Figure 6-4. Power-On Reset (RESET and TRST active) Timing

Case 1

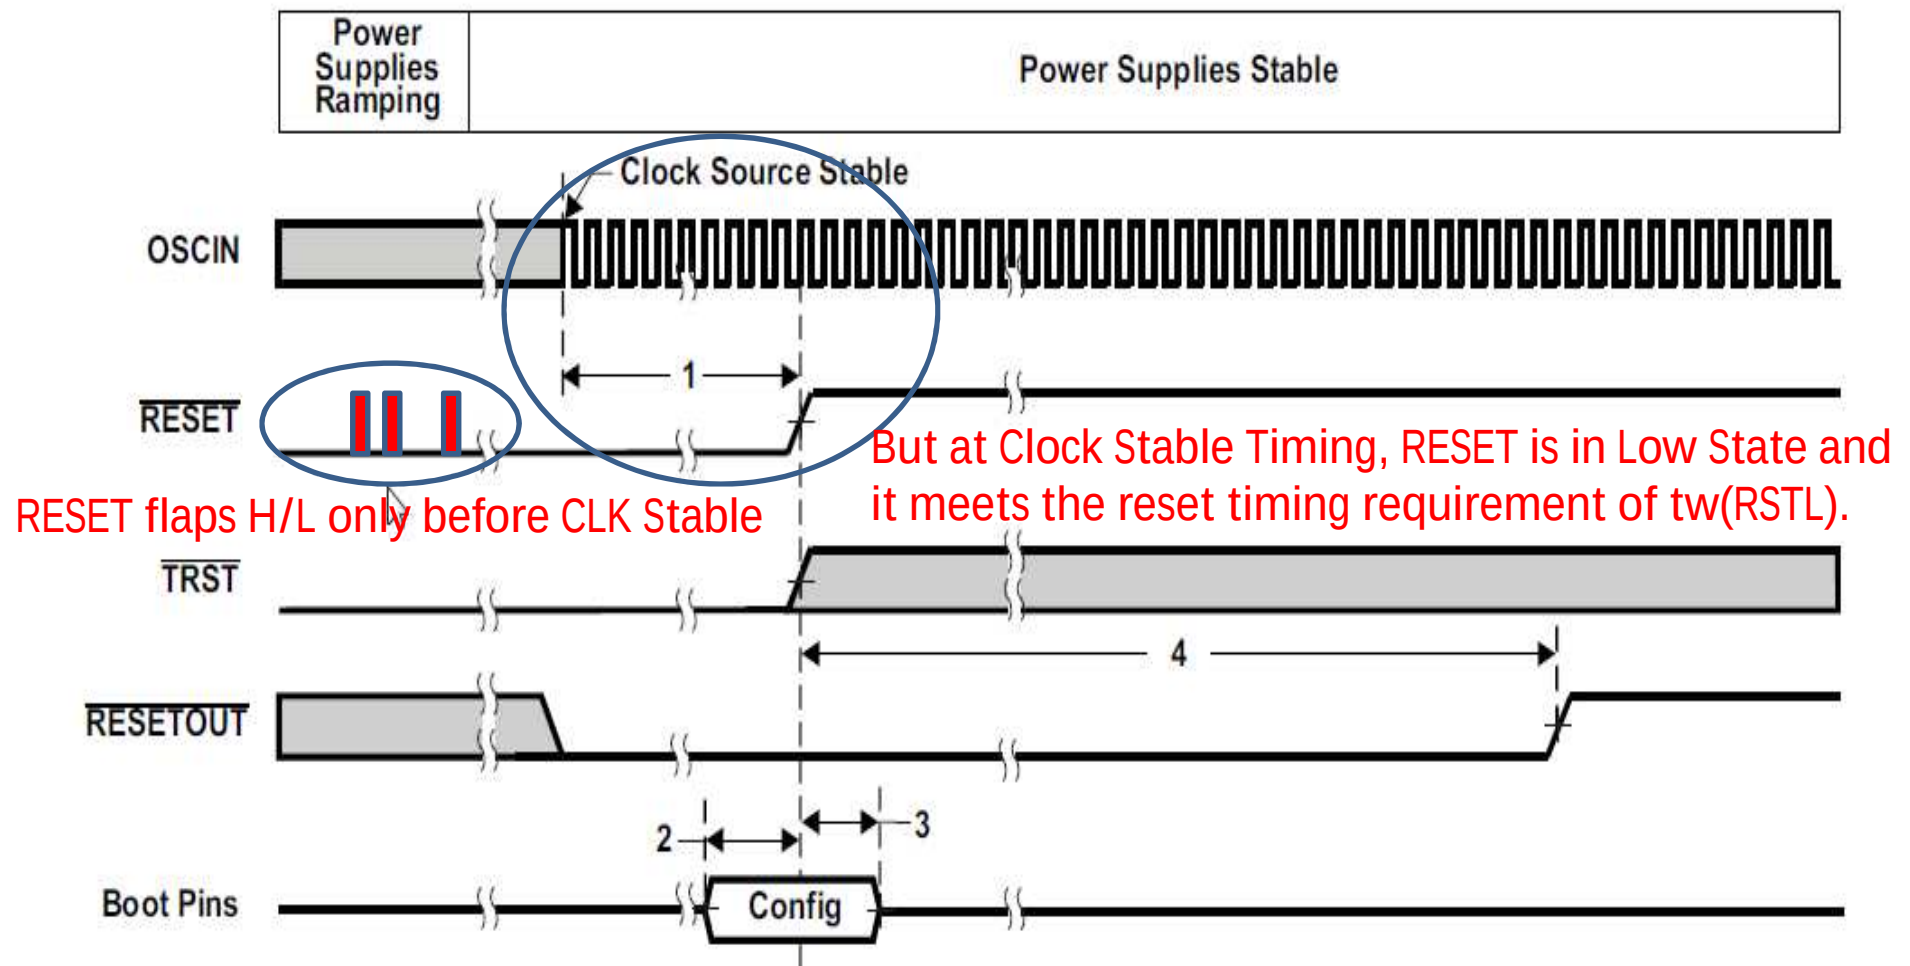
In this case, can I think as that the reset timing requirement is met?

Case2

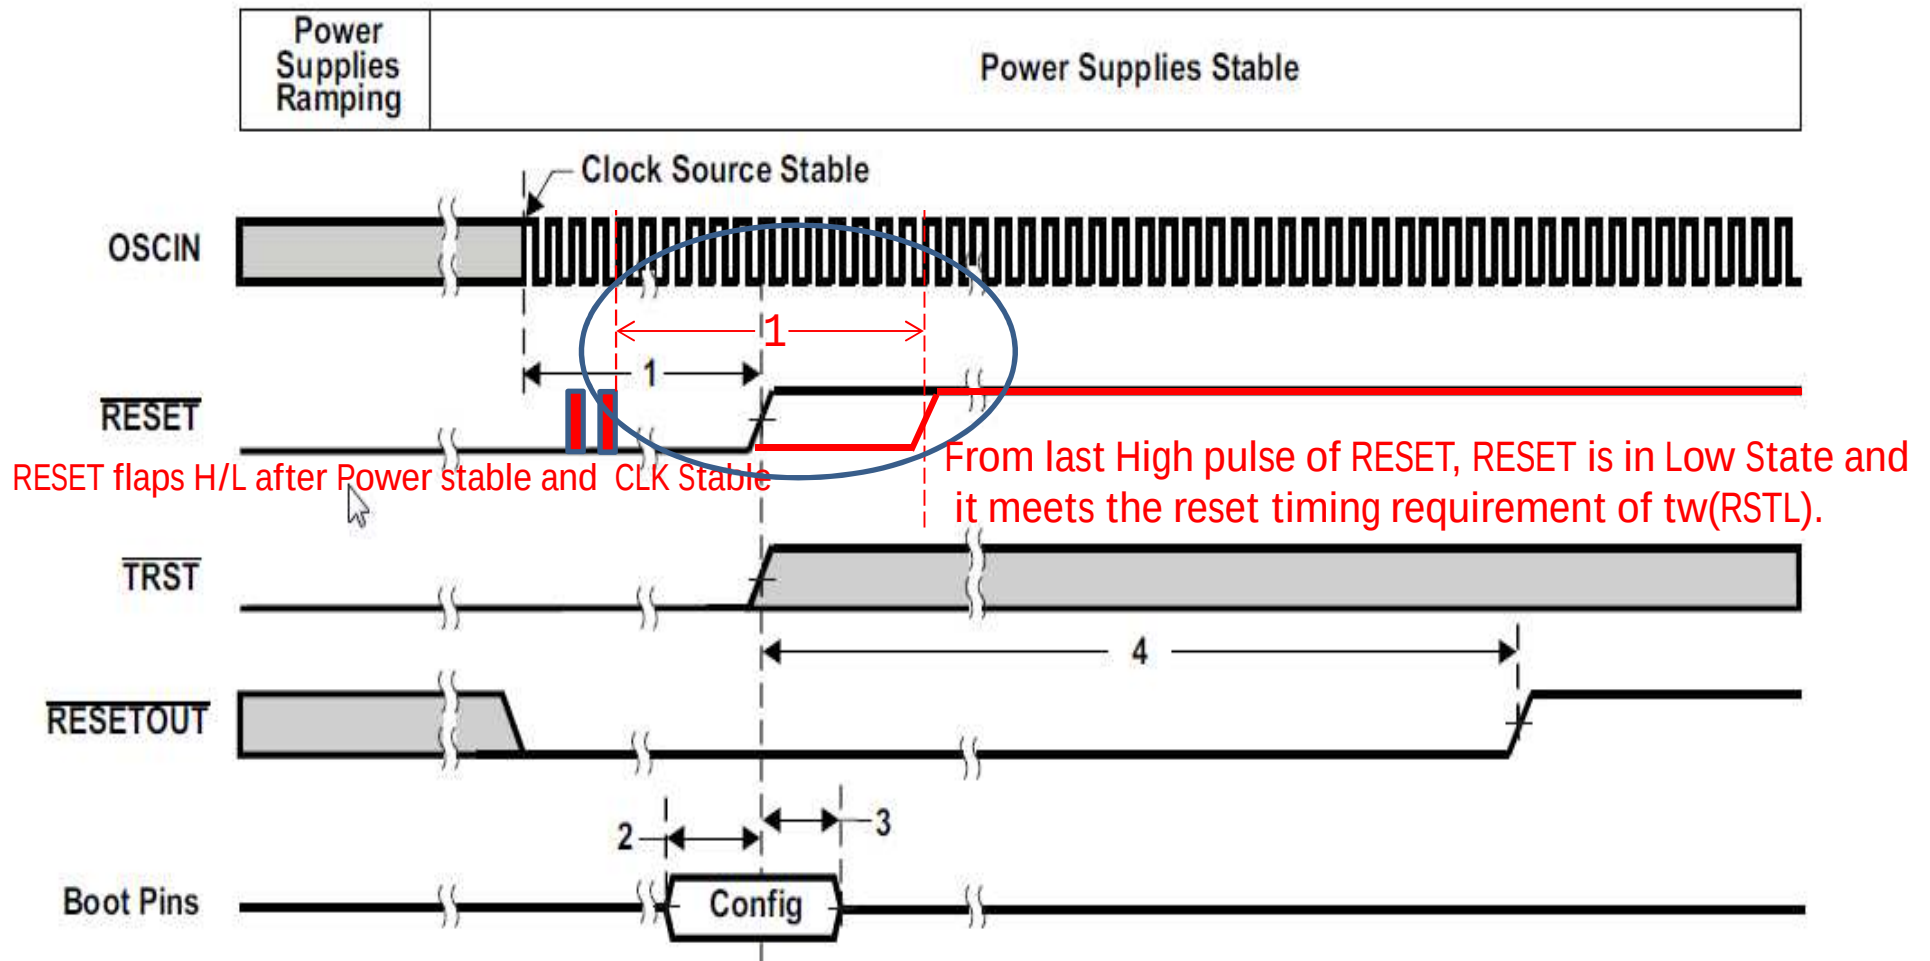
In this case, can I think as that the reset timing requirement is met?

Case3

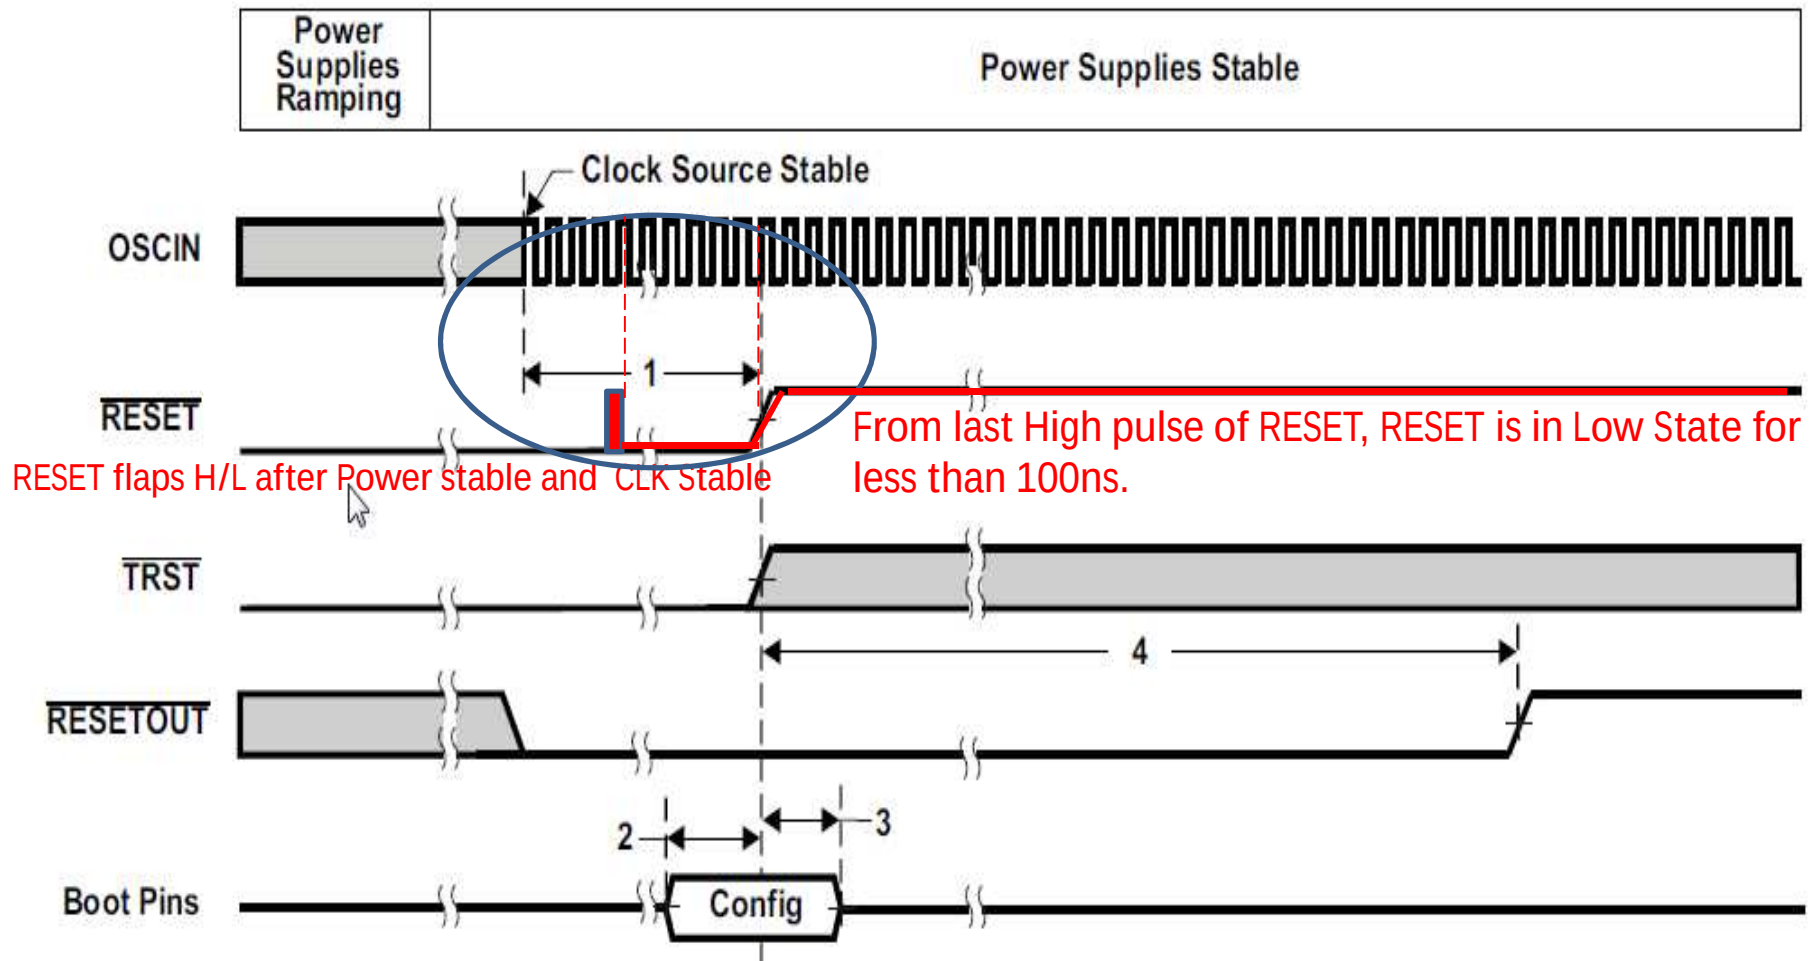
In this case, can I think as that it doesn't meet the reset timing requirement ?
